8000 WISCONSIN AVENUE

SKETCH PLAN PLAN NO. 320180120

PROJECT: 8000 Wisconsin Avenue (Artena Bethesda)
Sketch Plan No 320180120

RE: Sketch Plan No. 320180120
8000 Wisconsin Avenue

SHEET No:
SK-1
320180120

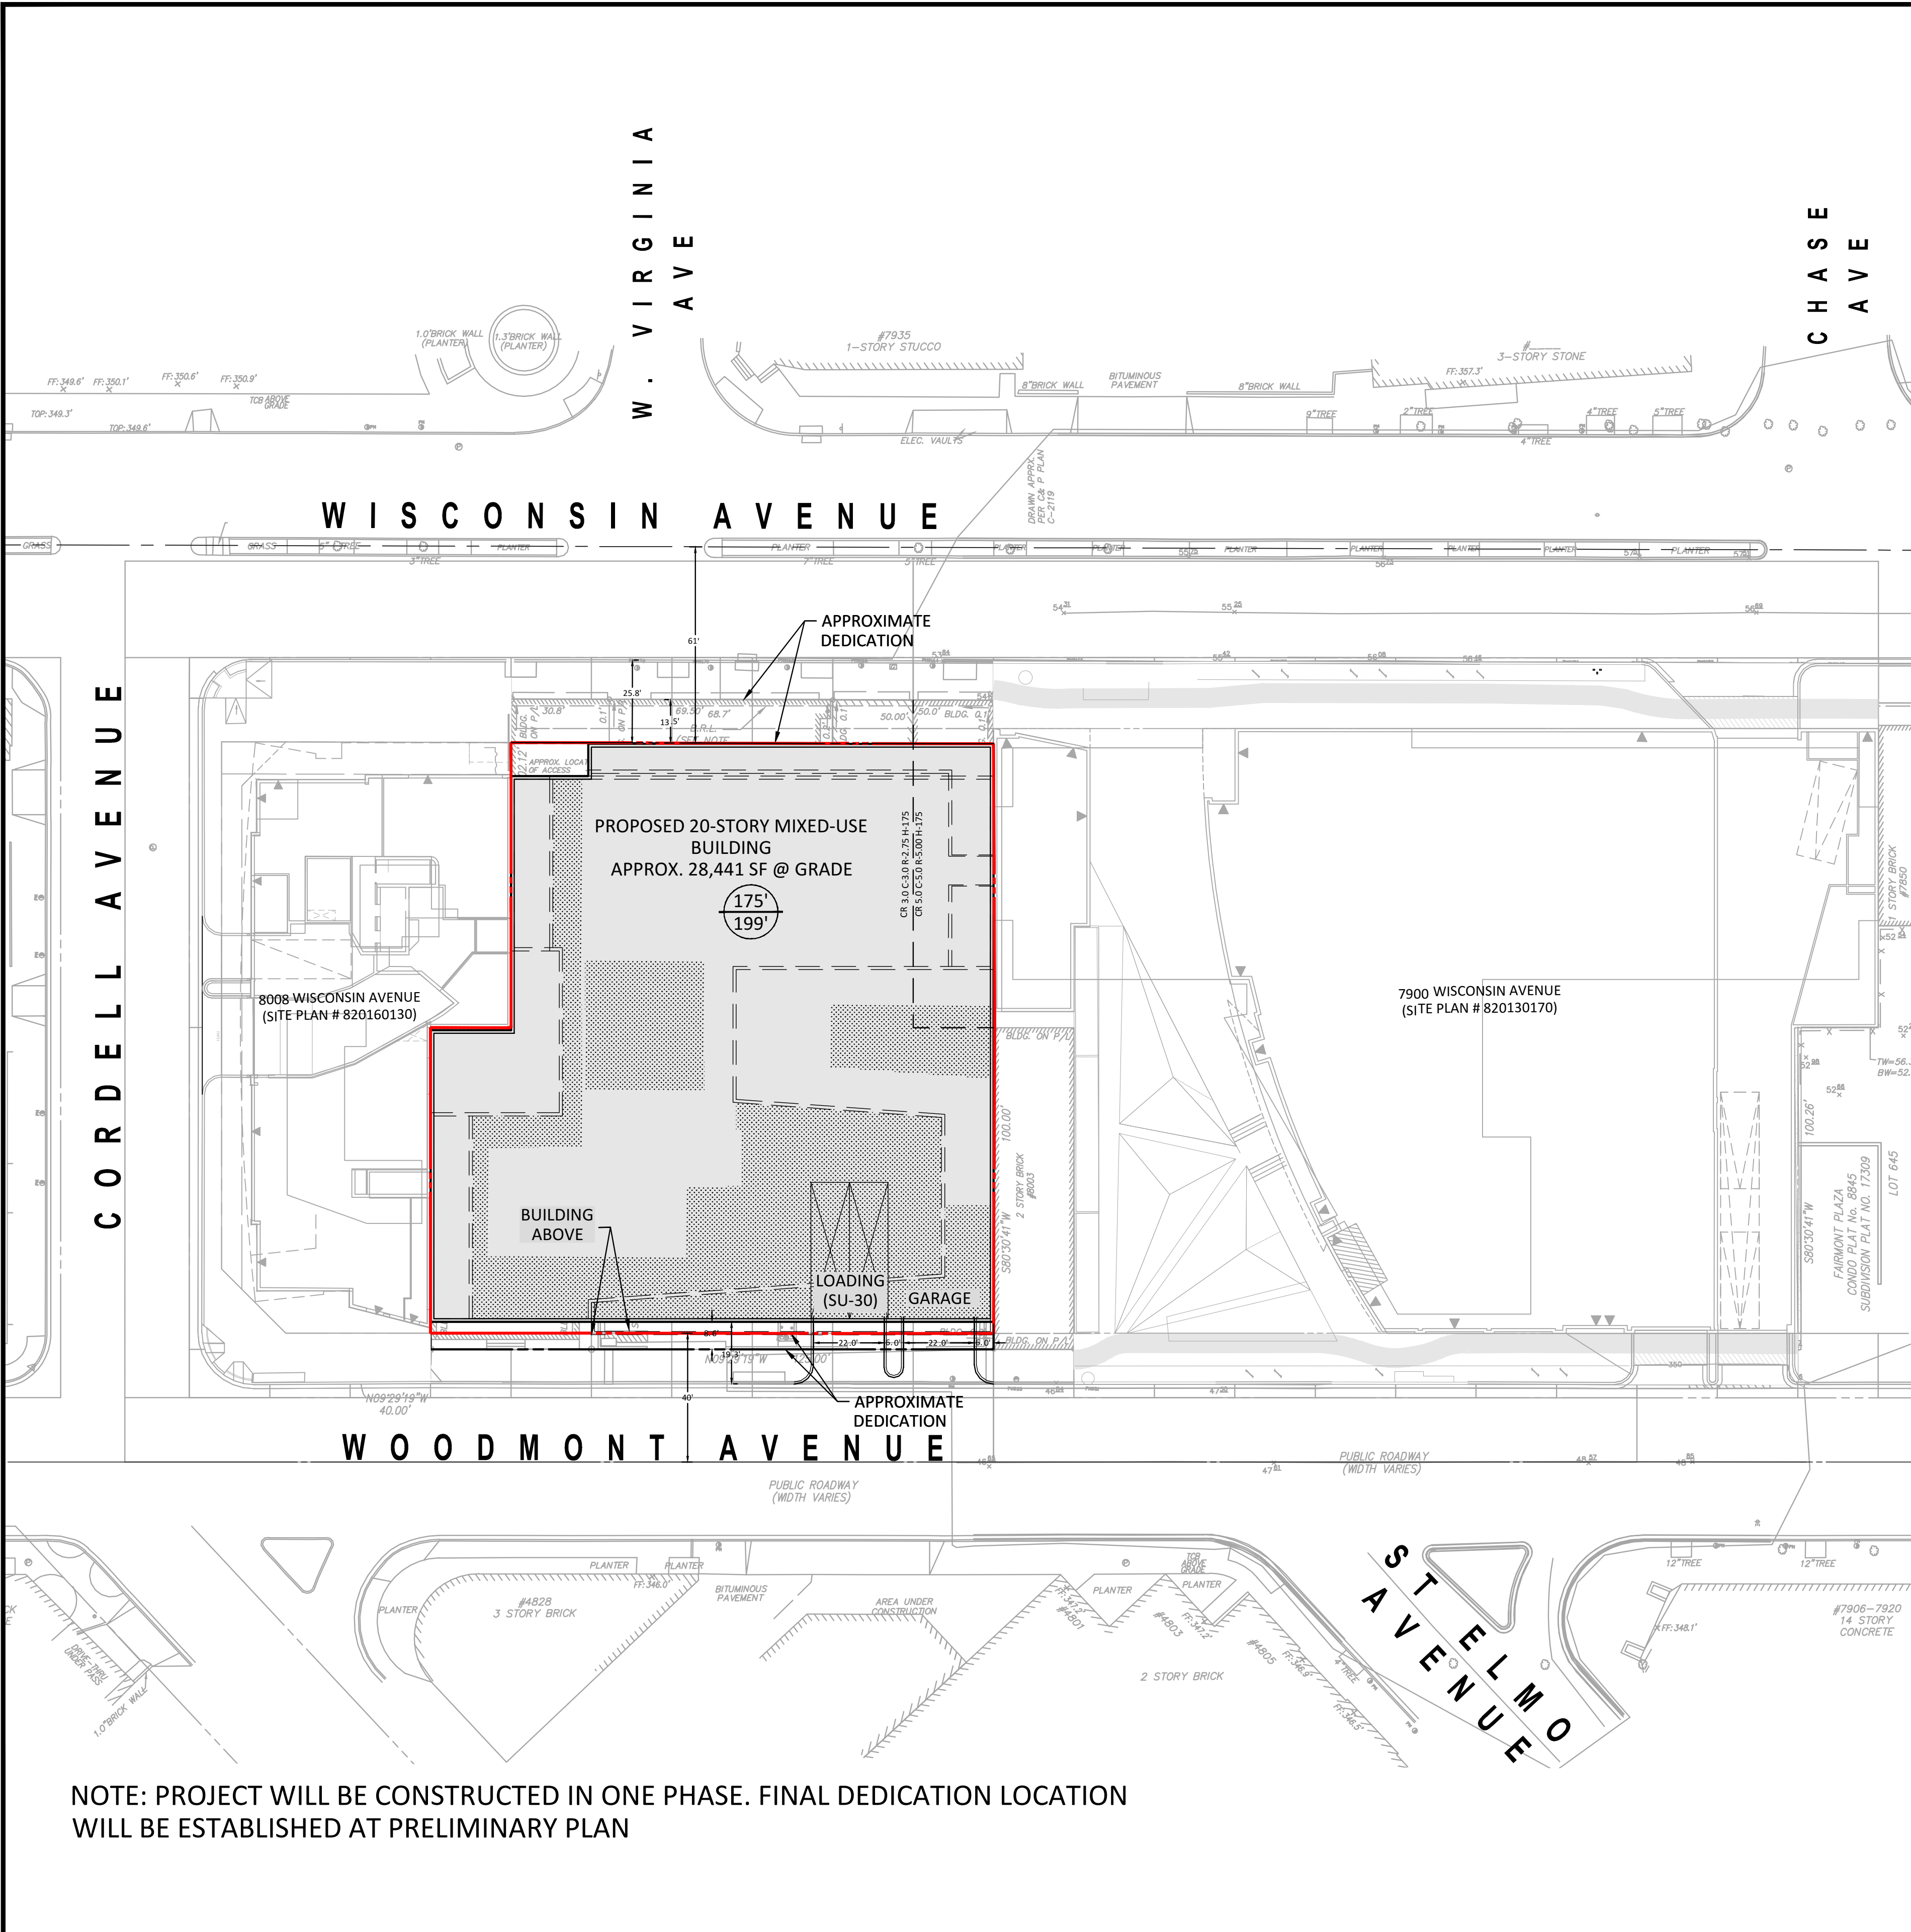
1. As noted in previous comments, the Parking Tabulations on Sheet SK-1 show one more efficiency MPDU than allowed. Please adjust so that there is one less efficiency MPDU and one more either two-bedroom or three-bedroom MPDU. While we acknowledge the applicant's comment that they intend to address the overall bedroom mix at Preliminary Plan/Site Plan, we do not want to have the Sketch Plan show an incorrect mix.
2. Please review the MPDU Minimum Specifications at the following link: http://montgomerycountymd.gov/DHCA/pubs_forms.html#MPDU.
3. Please schedule a meeting with DHCA to review schematic floor plans before submitting future plans to the Planning Department.
